United States Nuclear Regulatory Commission

Presentation to the Commission

Combined License Application Review

Vogtle Units 3 and 4

Vogtle Switchyard Configuration

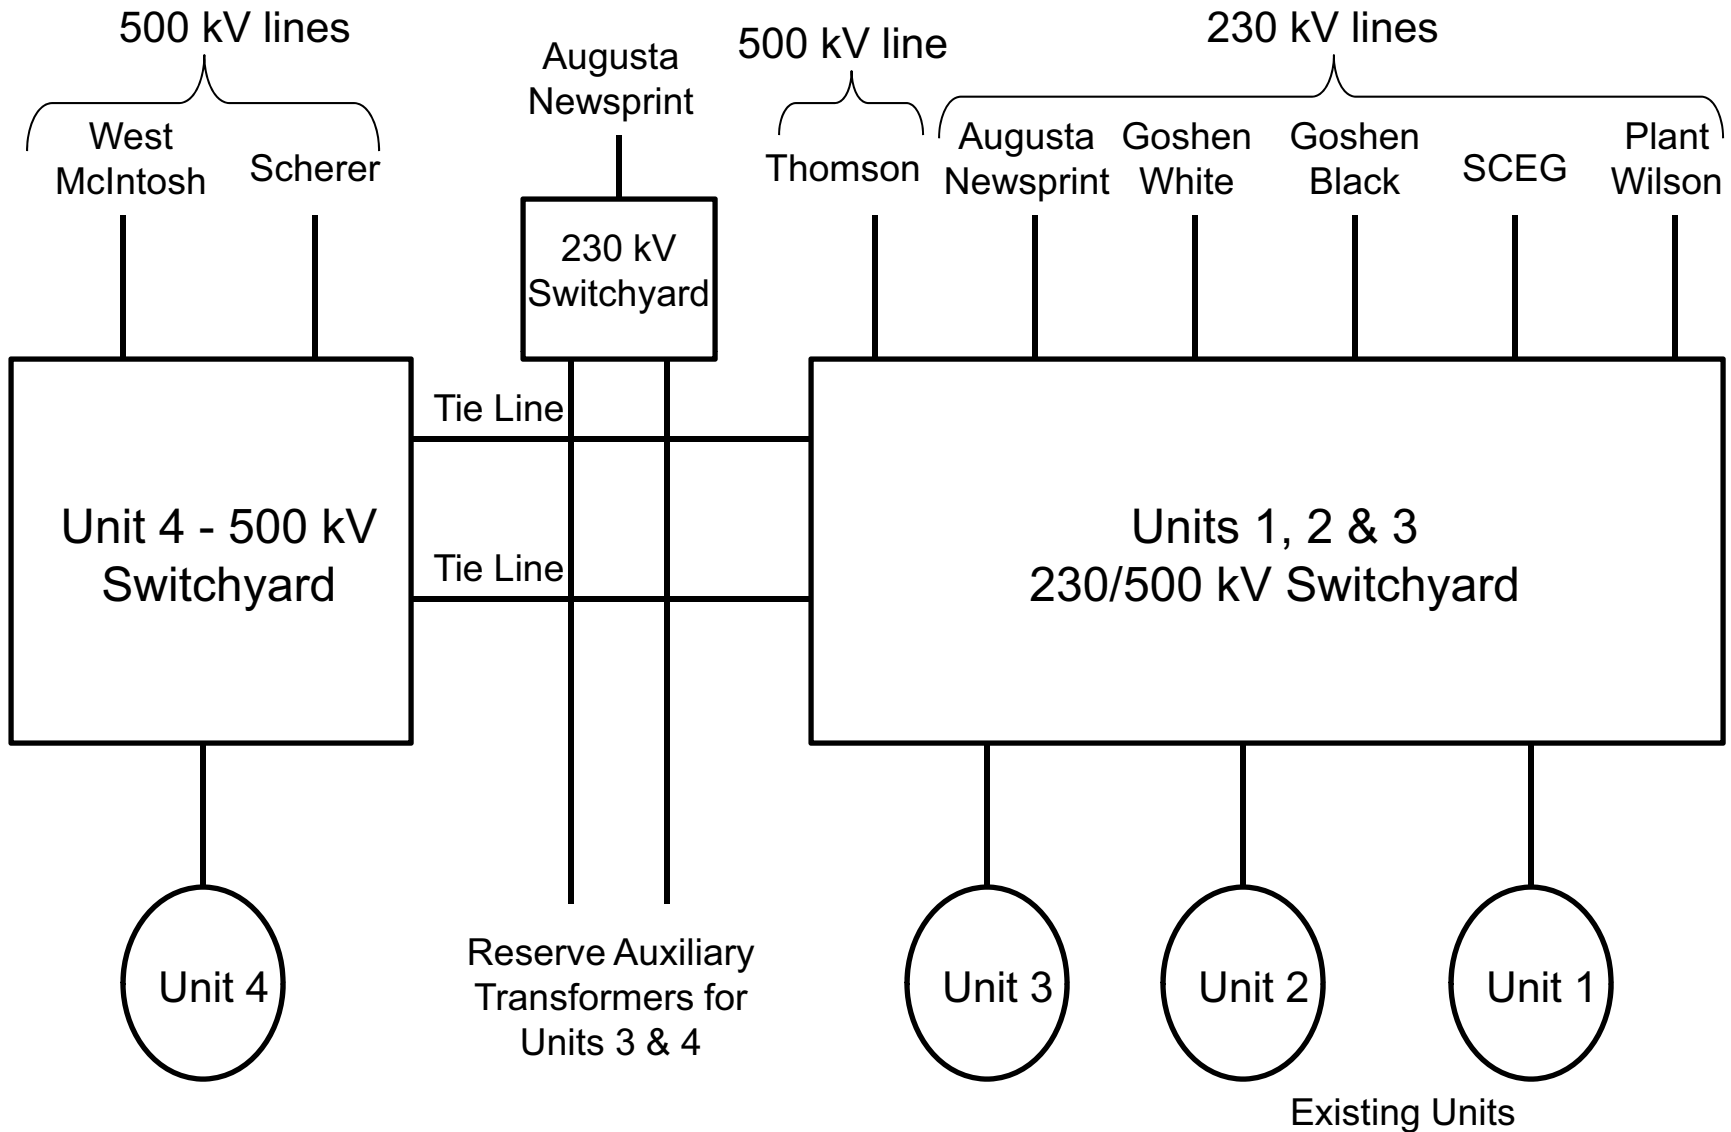
- Unit 3 is connected to the 230/500 kilovolt (kV) switchyard, which is supplied by five 230kV overhead transmission lines and one 500 kV overhead transmission line coming from other substations.
- Unit 4 is connected to a different 500 kV switchyard, which is supplied by two 500kV overhead transmission lines coming from other substations.
- Grid stability analysis was performed by the applicant to satisfy the DCD interface requirement for maintaining adequate reactor coolant pump voltage for 3 seconds after a turbine trip, which was accepted by the staff.
